**FINAL  
ENVIRONMENTAL IMPACT REPORT**

**HARPER CANYON (ENCINA HILLS)  
SUBDIVISION**

SCH# 2003071157  
PLN 000696

2.0 RESPONSE TO COMMENTS..... 2-1

AMENDMENTS TO SECTION 3.10, TRANSPORTATION AND CIRCULATION

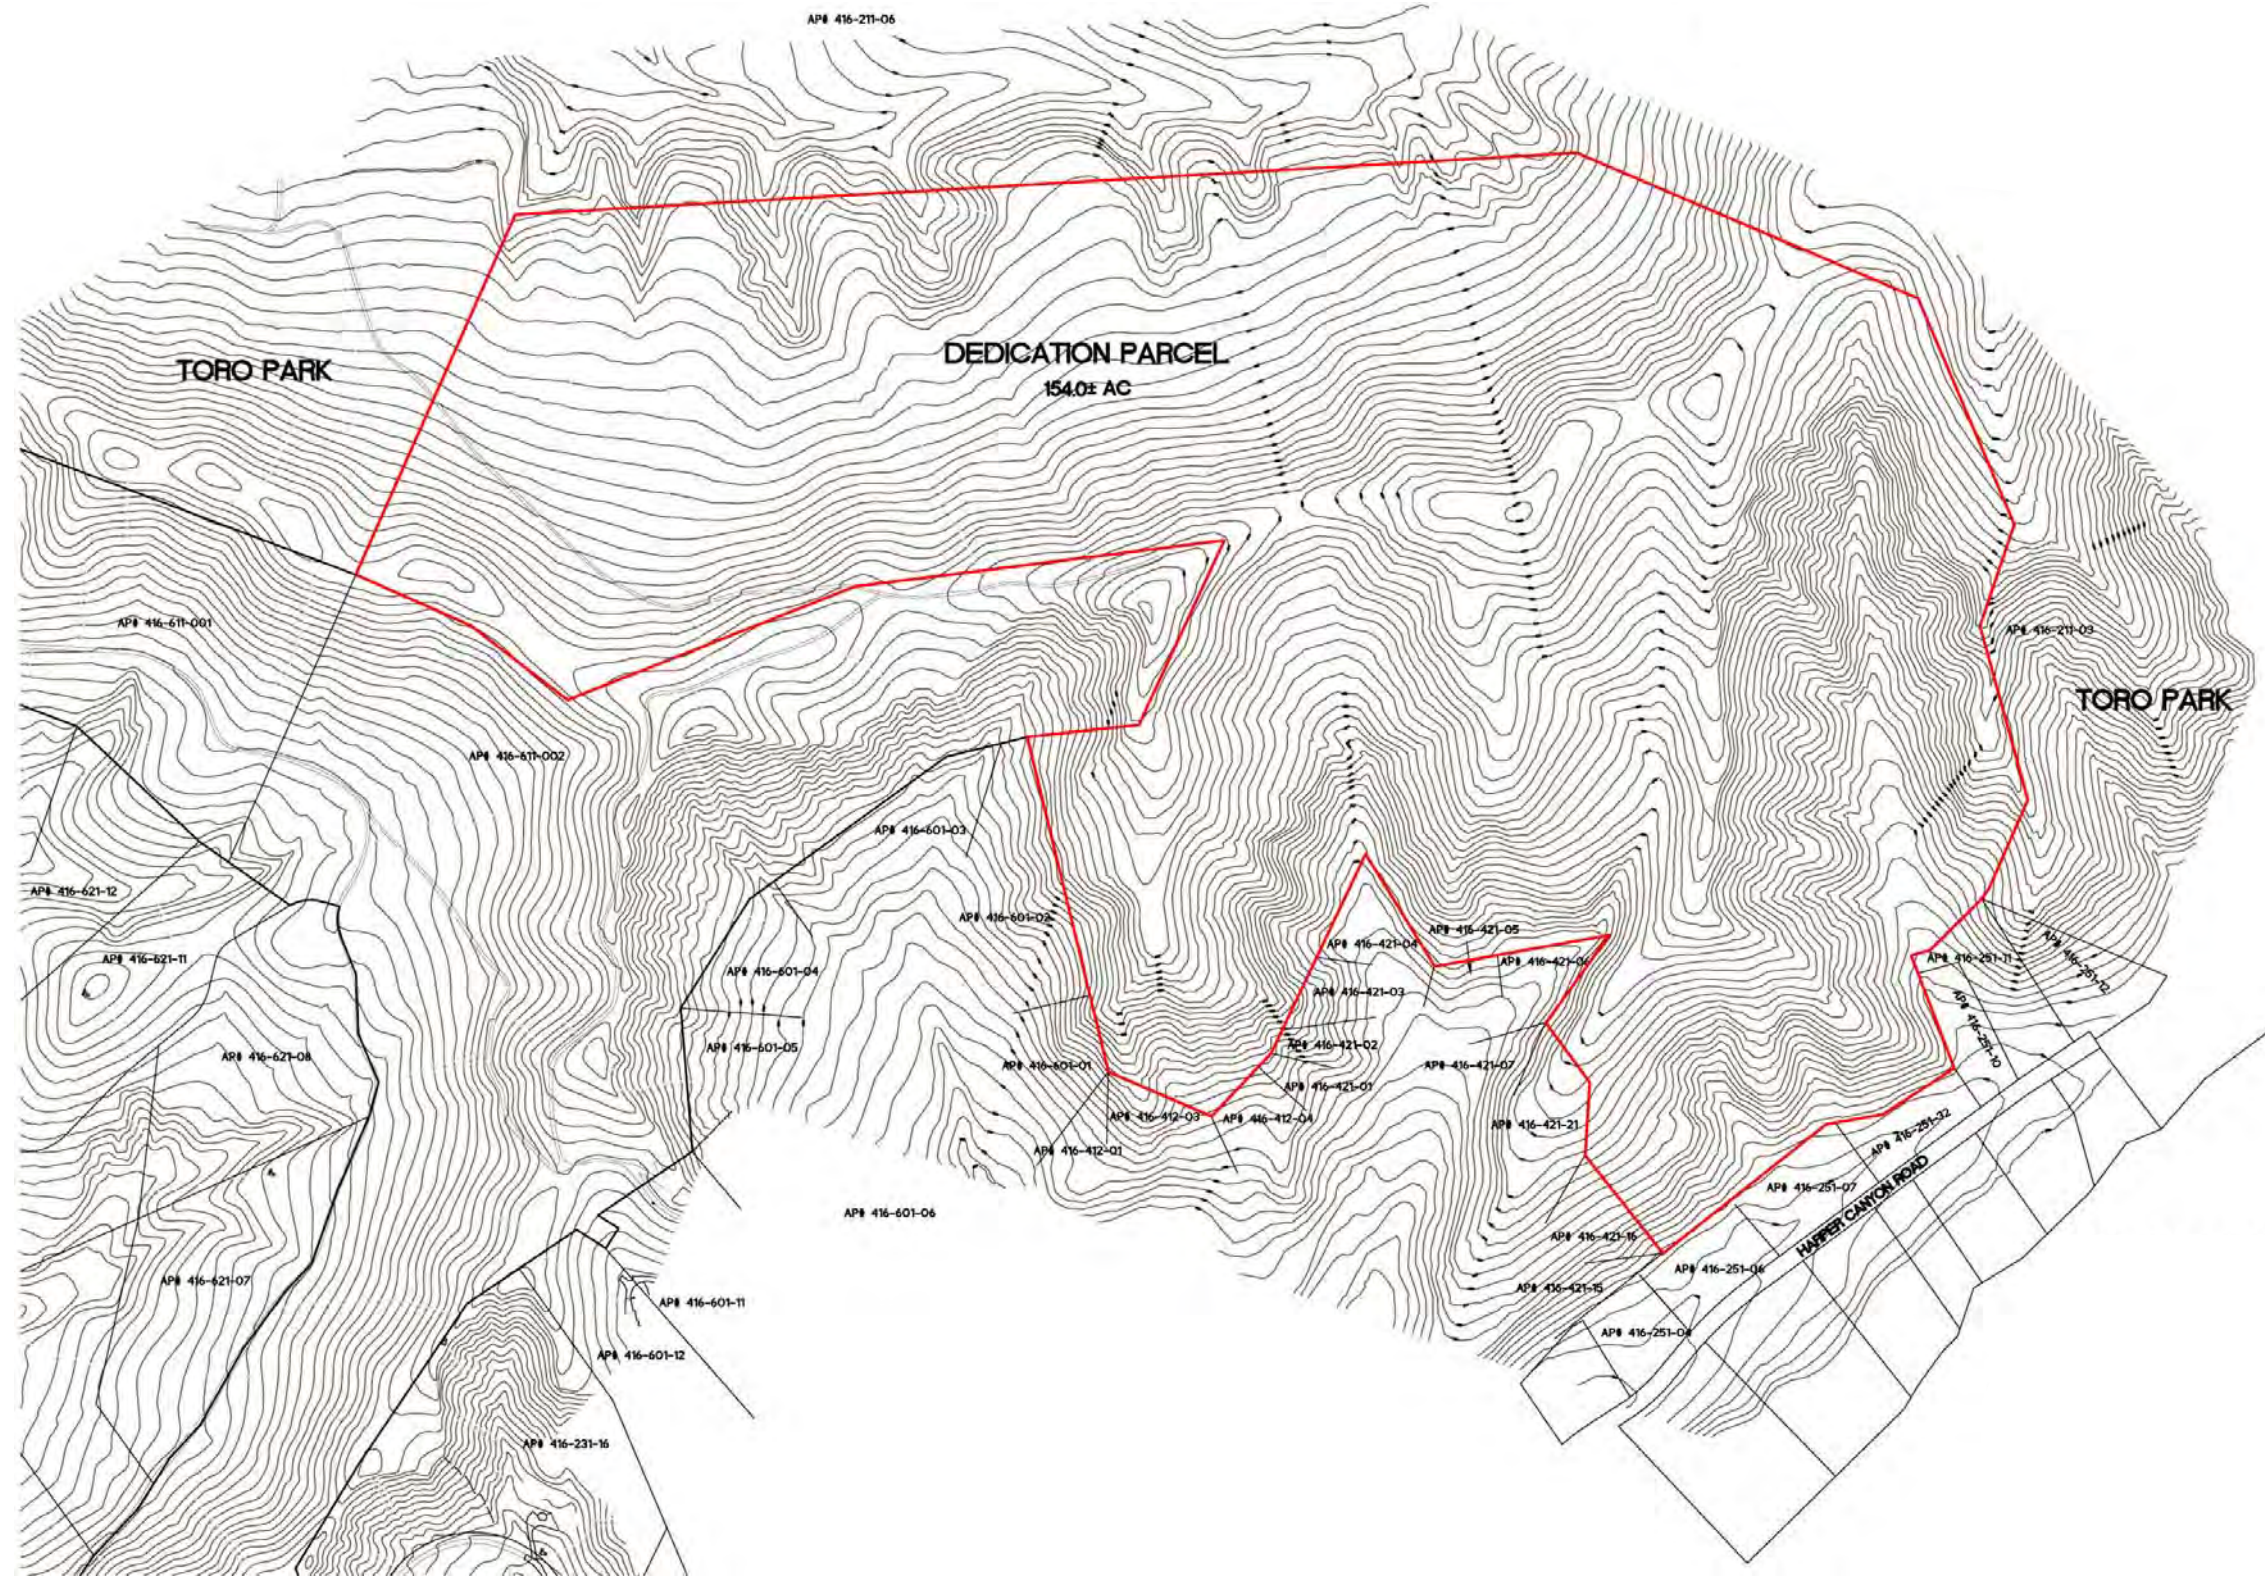
Exhibits 6 and 7 of the Traffic Impact Analysis prepared by Hatch Mott MacDonald have been revised to describe Highway 68 as a 2-lane rural highway in lieu of a 2-lane arterial. The revisions to the Traffic Impact Analysis are provided in Exhibits D and E, respectively, of this FEIR.
